NIAGARA MOHAWK POWER CORPORATION
LICENSE NO. DPR-63
DOCKET NO. 50-220

Proposed Changes to the Current Technical Specifications (TS)

Replace existing pages 84, 85, 86, 87, 88, 89, 90, 91, 92, 93, 94, and 95 with the attached revised pages. These pages have been retyped in their entirety with marginal markings to indicate changes to the text. Also, pages 94a, 94b, 94c, and 94d have been added.

Marked Up Copy of Technical Specifications

FIGURE 3.2.2.e

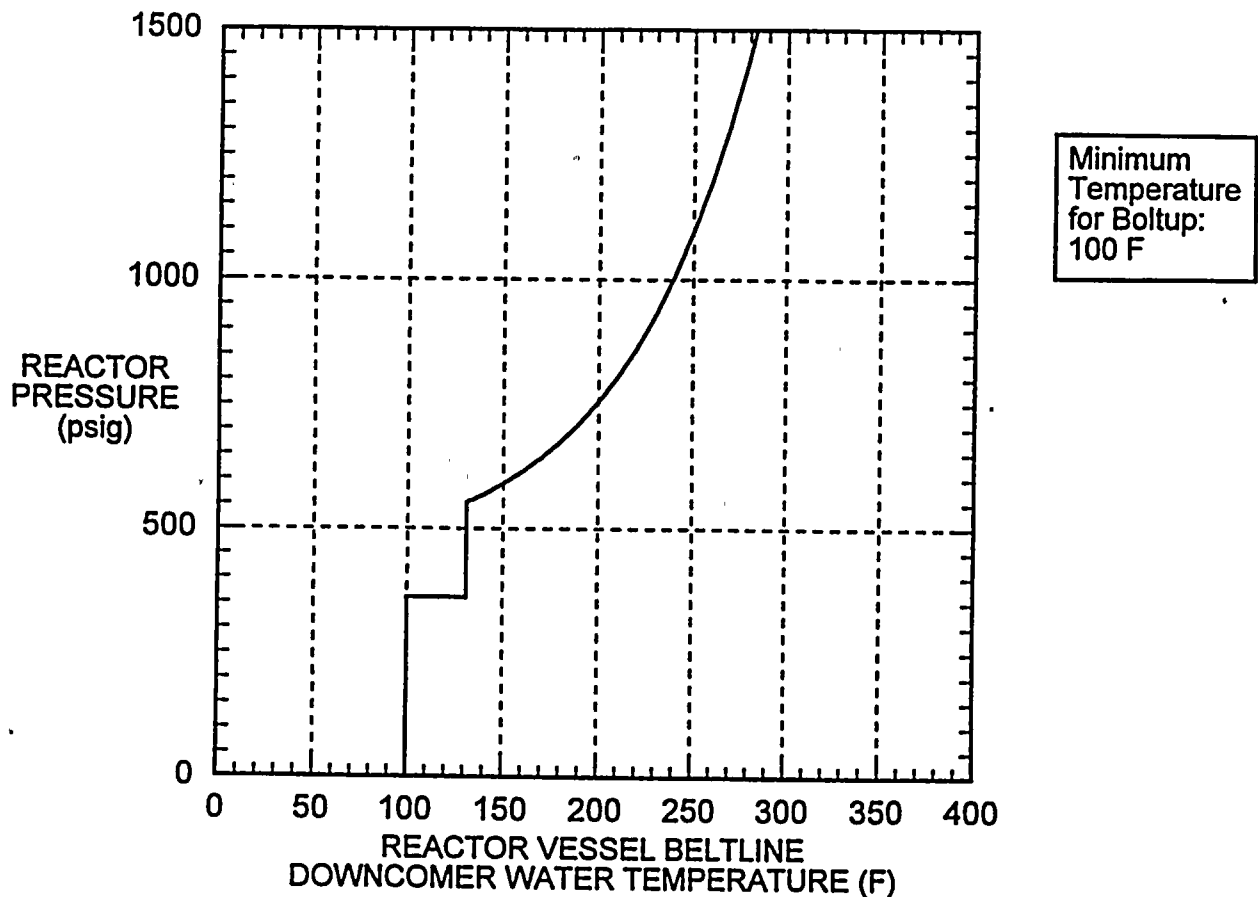
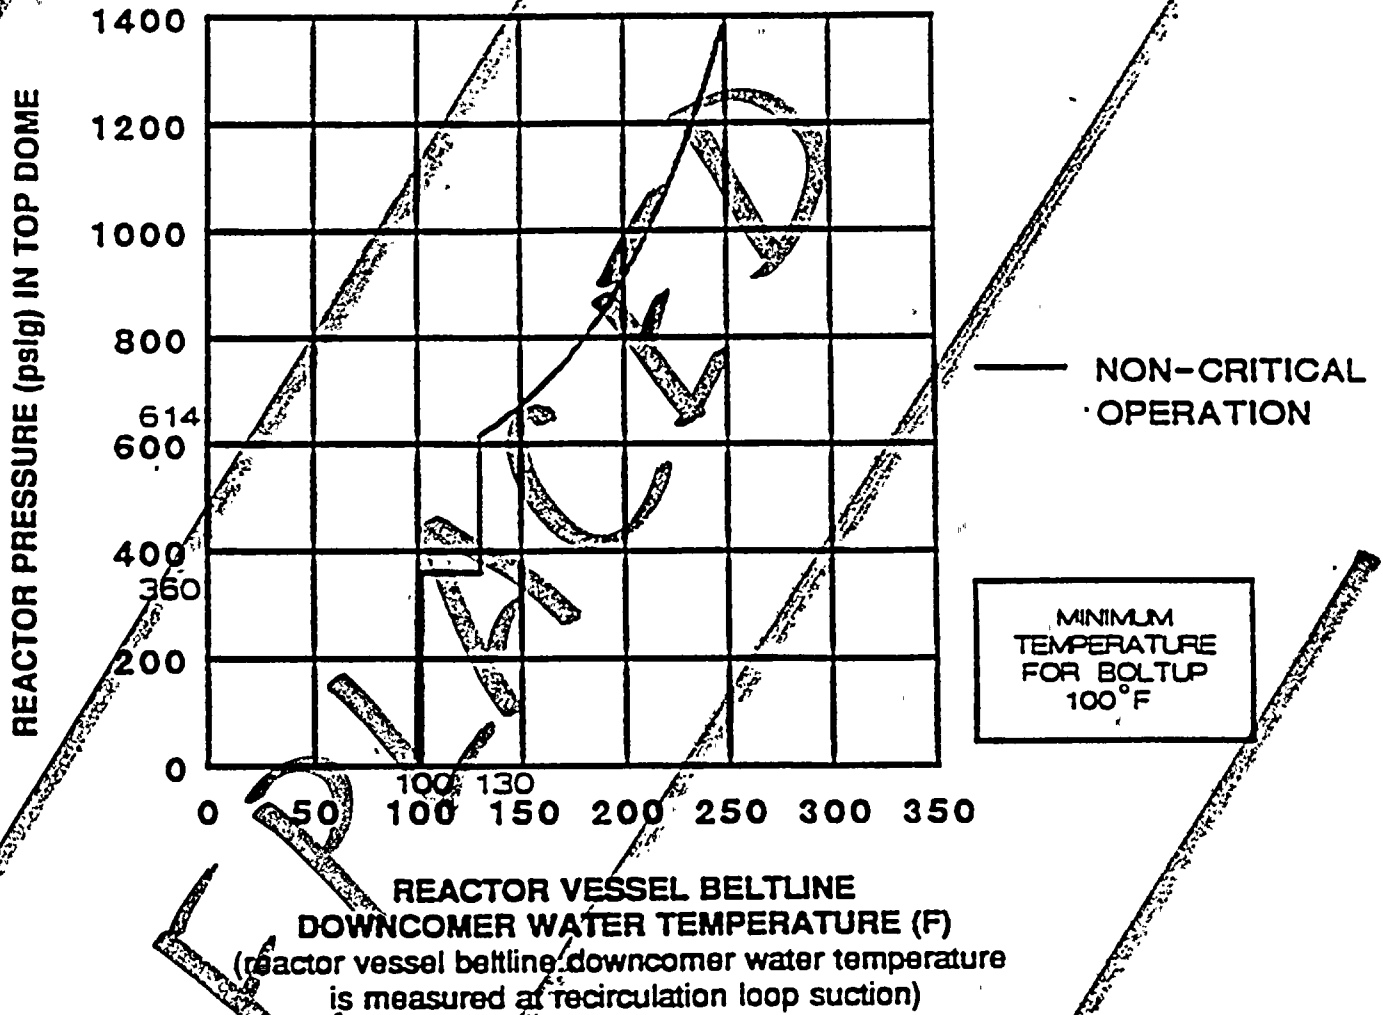
**MINIMUM BELTLINE DOWNCOMER WATER TEMPERATURE FOR
PRESSURIZATION DURING IN-SERVICE HYDROSTATIC TESTING
AND LEAK TESTING (CORE NOT CRITICAL) FOR UP TO
28 EFFECTIVE FULL POWER YEARS OF OPERATION**

MINIMUM BELTLINE DOWNCOMER WATER TEMPERATURE FOR PRESSURIZATION DURING IN-SERVICE HYDROSTATIC TESTING AND LEAK TESTING (REACTOR NOT CRITICAL) FOR UP TO 16 EFFECTIVE FULL POWER YEARS OF OPERATION

REPLACED

FIGURE 3.2.2.f

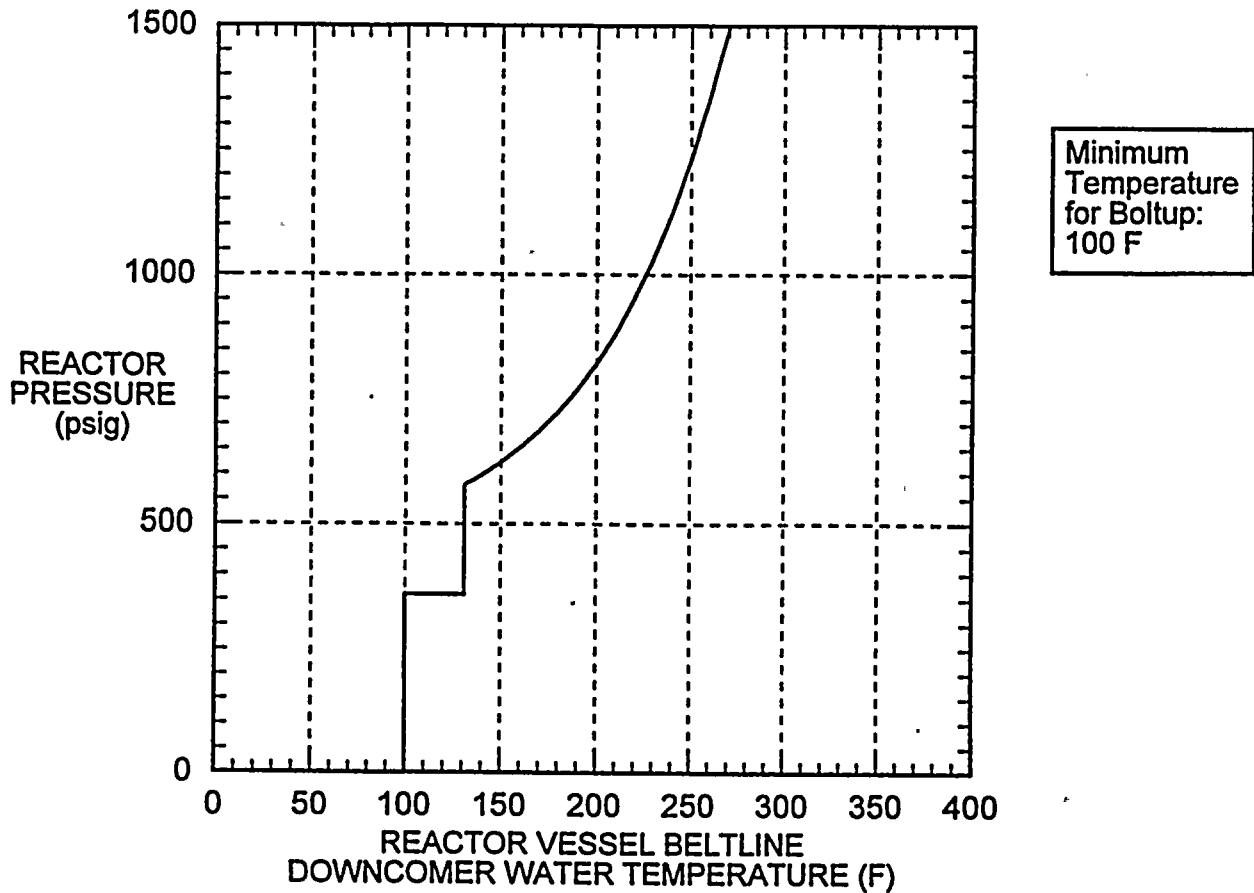
**MINIMUM BELTLINE DOWNCOMER WATER TEMPERATURE FOR
PRESSURIZATION DURING IN-SERVICE HYDROSTATIC TESTING
AND LEAK TESTING (CORE NOT CRITICAL) FOR UP TO
20 EFFECTIVE FULL POWER YEARS OF OPERATION**

Curves 3.2.2.f and 3.2.2.g are applicable for up to 20 and 24 effective full power years, respectively.

FIGURE 3.2.2.g

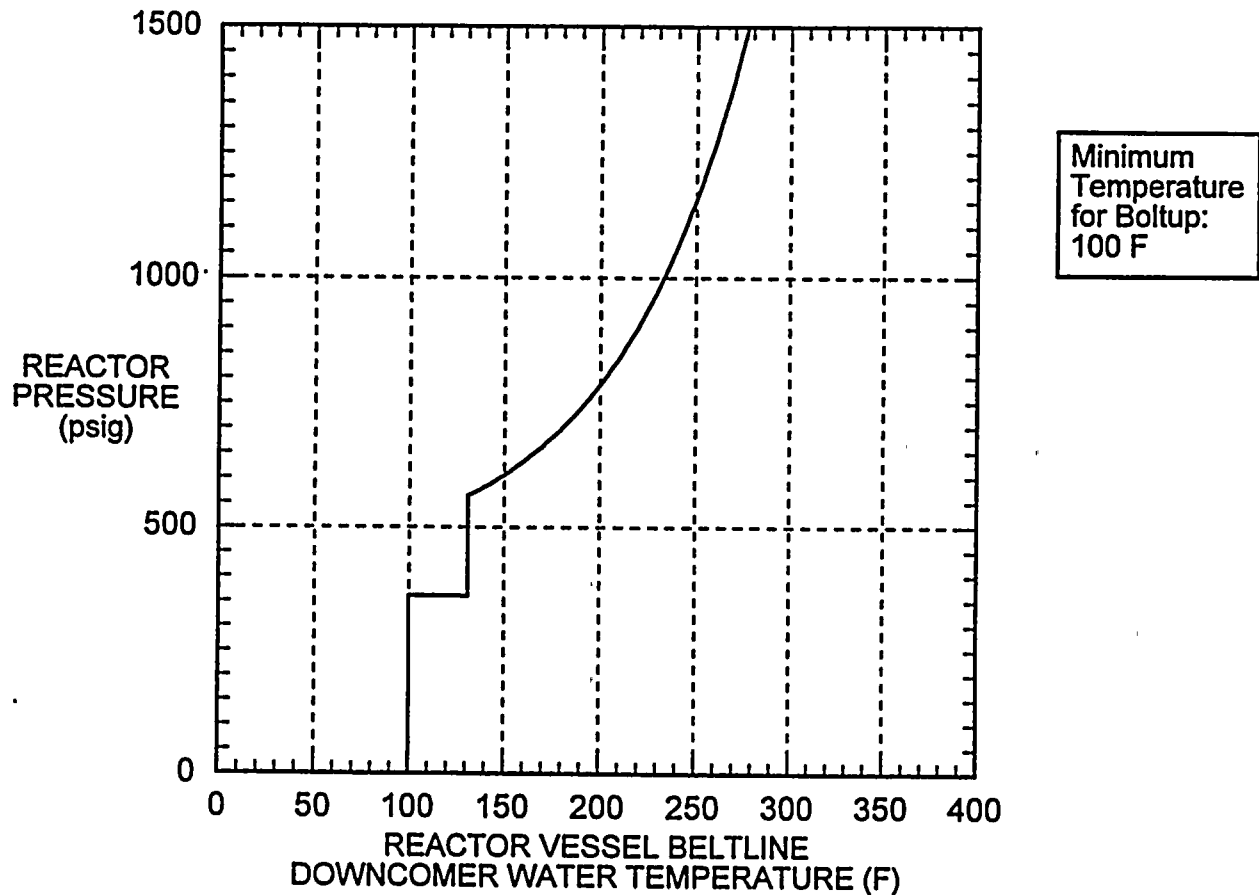
**MINIMUM BELTLINE DOWNCOMER WATER TEMPERATURE FOR
PRESSURIZATION DURING IN-SERVICE HYDROSTATIC TESTING
AND LEAK TESTING (CORE NOT CRITICAL) FOR UP TO
24 EFFECTIVE FULL POWER YEARS OF OPERATION**
